Re: 24-25-03PD - Jurupa USD Districtwide Exterior Cameras – Addendum #2

**ITEM #4      Revisions to Plans (*Revised Plans attached below*):**

Jurupa Unified Districtwide Camera Project - Camera Schedule by Site\_Addendum 02

**T1.01**

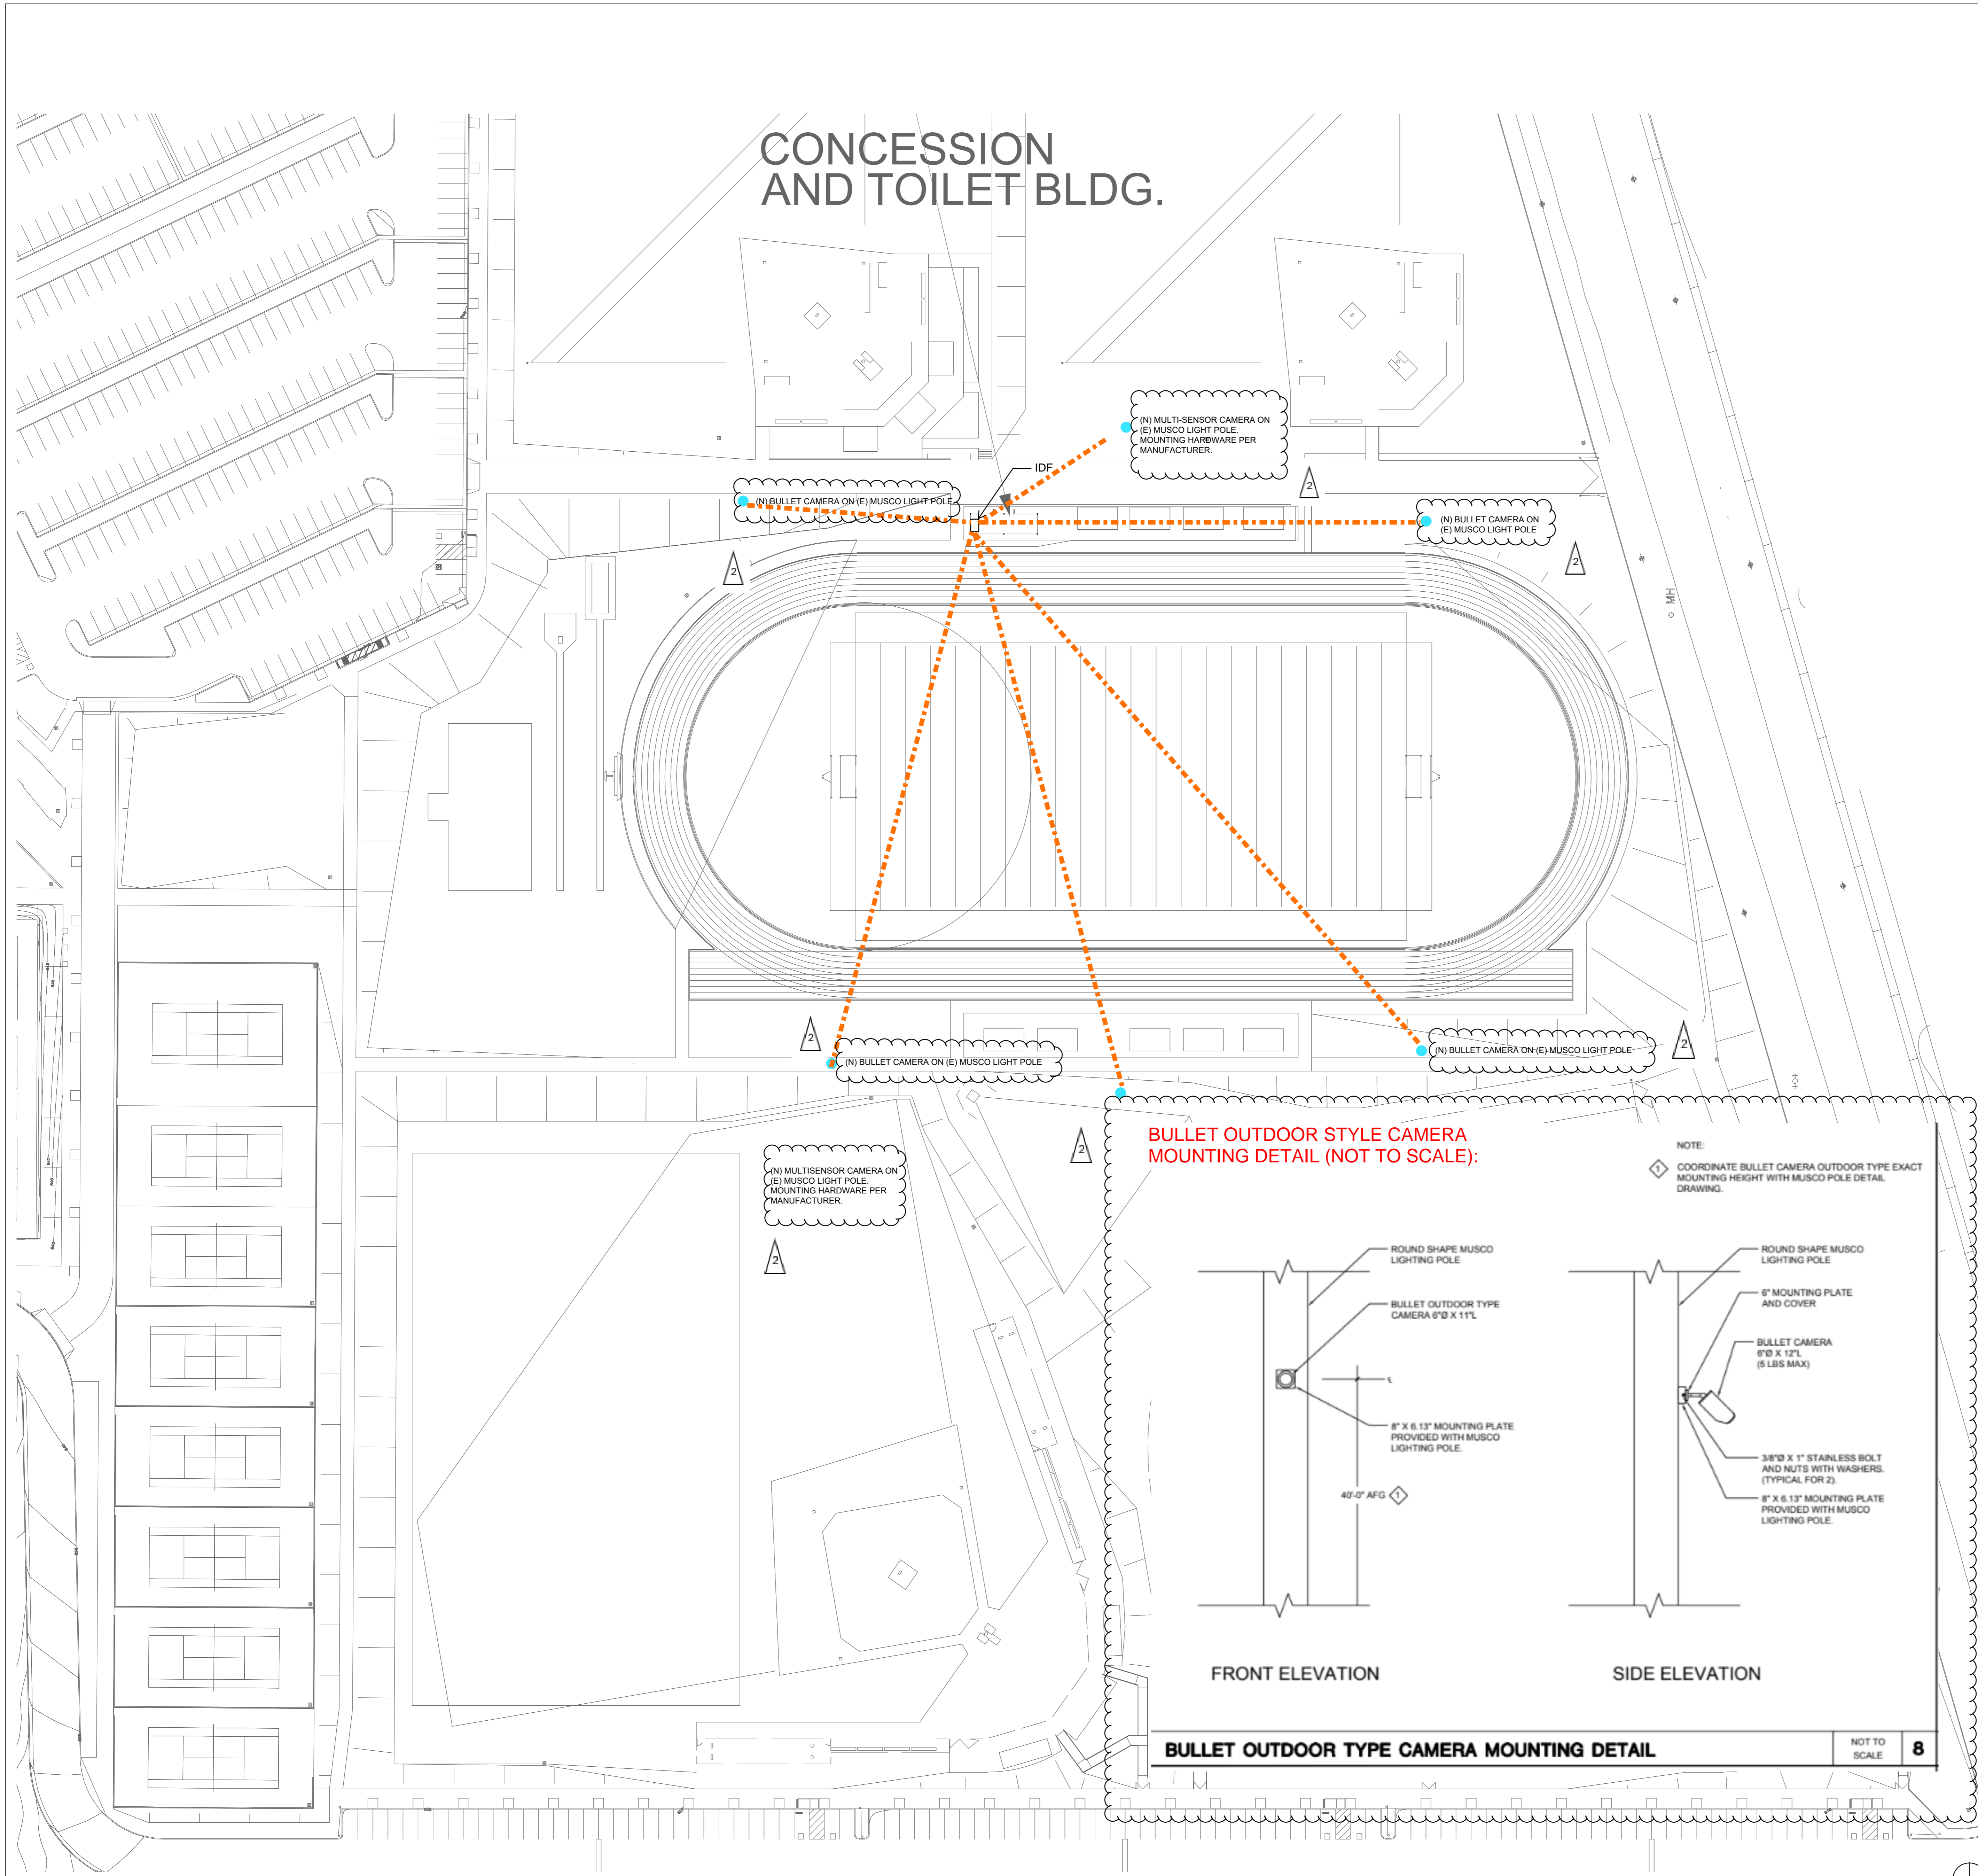
**Question:** Patriot High School - What camera models do the district want on the stadium musco lights? What is the voltage at the light poles? Are they constant power or on a timer? Are there existing outlets on the light poles?

**Question:** Patriot High School has 6 Cameras on the Field but with no specification. Need FOV and Zoom information

**Question:** Patriot High School has 6 cameras on Light Poles, should we assume that they need Data / Power provided by some kind of Cellular Gateway? Or are you going to run new cable in the light pole?

**Answer:** Basis of design for Patriot High School stadium lights are 4 bullet-style cameras and 2 multi-sensor cameras. The Musco lights are fed from a distribution board, and the poles are 480V. The lights are on a schedule that was set up by the District using the “Control-Link” monitoring system that comes with the Musco lights. There is a manual switch for power shut-off at the Musco Control and Monitoring Cabinet in the (E) electrical yard. There are not existing outlets on the poles.

**Answer:** See Addendum 2 Patriot High School Plan sheet for camera types.

**Answer:** Existing pathways and cabling exist at those locations.
